**RFB-2023-62**  
**RENOVATIONS TO: SCHENECTADY COUNTY COURTHOUSE RESTROOM**  
**C2 DESIGN GROUP**

**ADDENDUM #1**

Project Site Location for Contractor's Dumpster & Staging Area	
PROJECT:	Renovations To: <b>Courthouse Restroom</b>
612 State Street, 1st Floor Schenectady, NY 12305

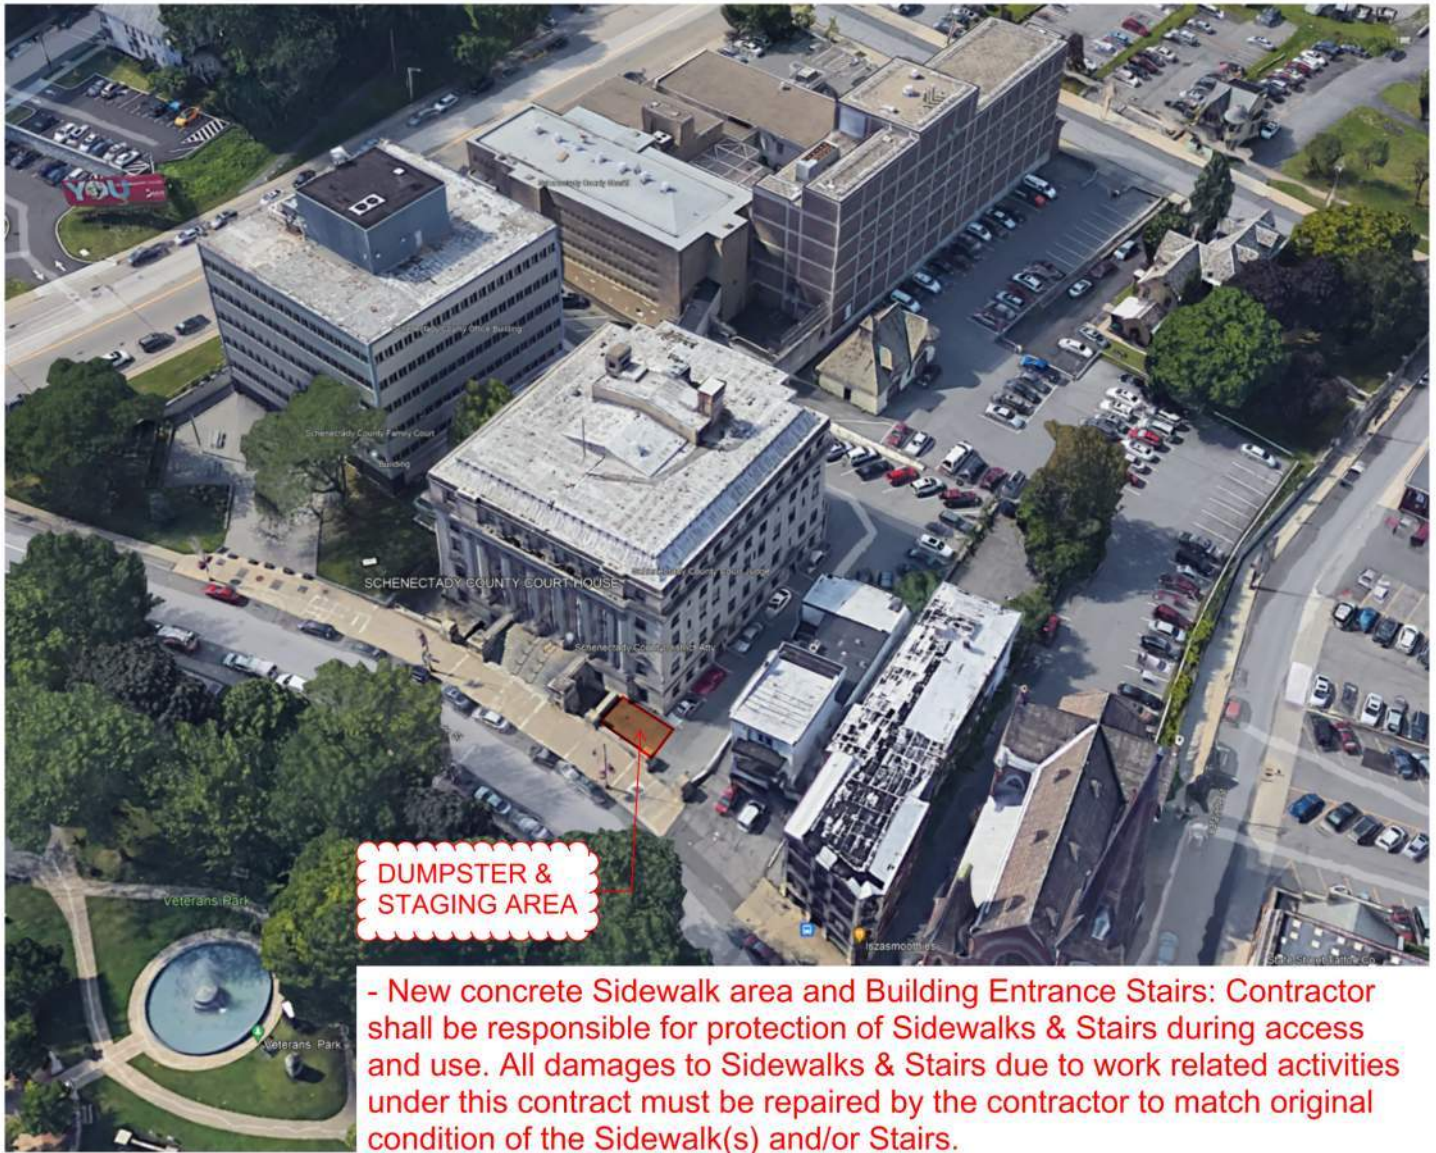
1. Are work hours from 7:00am – 3:30pm?
  - a. Response: Yes, the contractor will be provided a FOB for access and can work their preferred hours.
2. Is there a possible location for dumpster on site?
  - a. Response: Yes, see SK-01
3. Are there security check-ins required for contractors daily?
  - a. Response: Security checks will not be required, but no tools or materials may be left unattended outside the bathroom in the public space. A lockable Jobox will be allowed to be kept in the public waiting area if needed.

SHEET TITLE:	Fire Alarm Comm. Path to Main COB Panel
PROJECT:	Renovations To: <b>Courthouse Restroom</b>
612 State Street, 1st Floor Schenectady, NY 12305

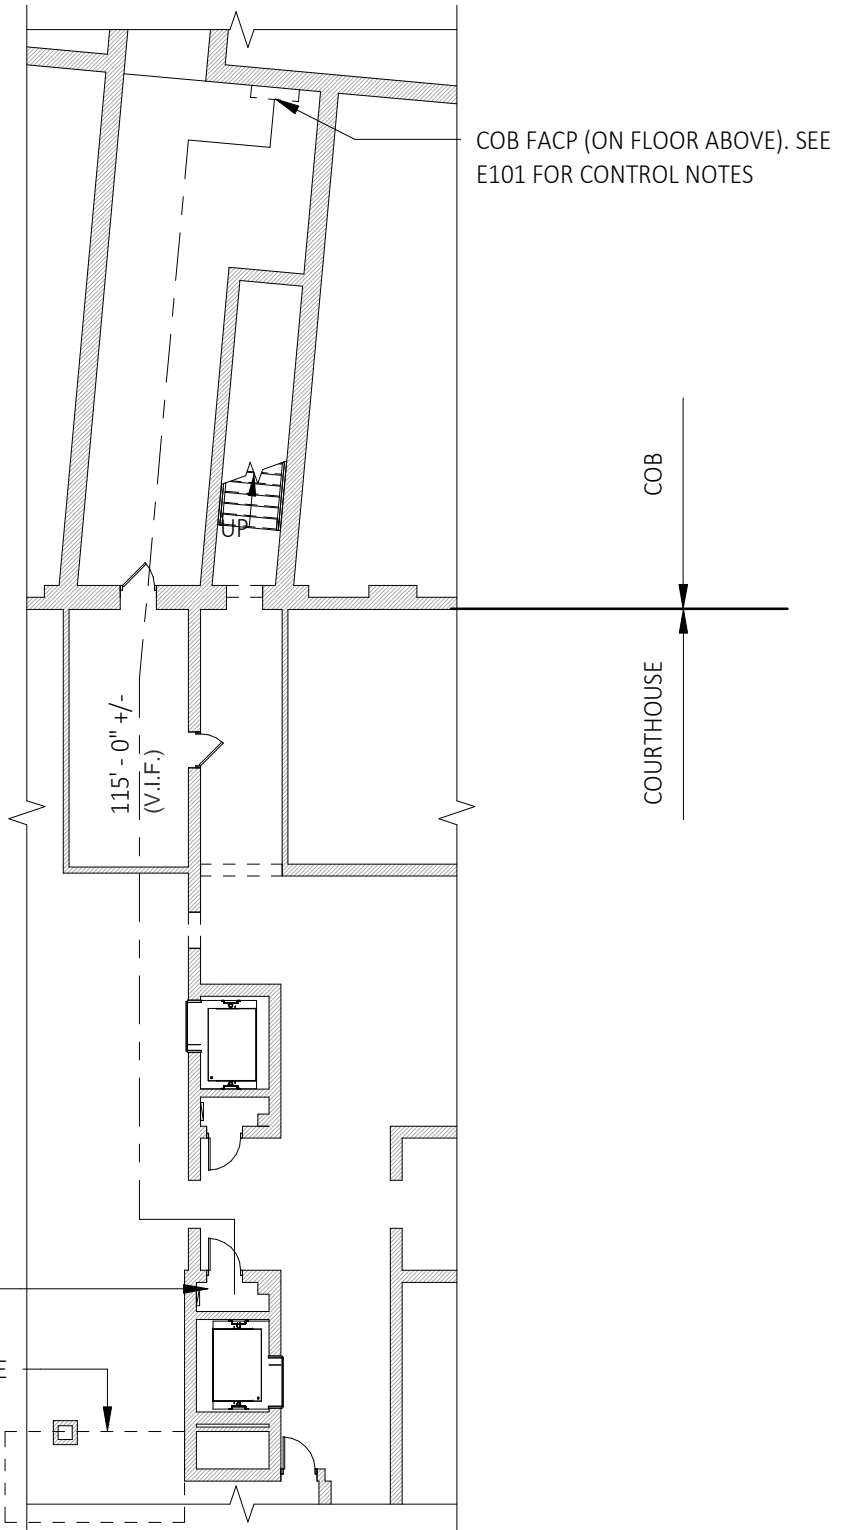
- **SK-01 Project Site location for Contractor's Dumpster & Staging Area**
- **SK-02 Project fire alarm communications path to main COB fire alarm panel**
- **#RFB-2023-62 Pre-bid Walk through Sign in Sheet (5/11/2023): Attended Contractor list.**
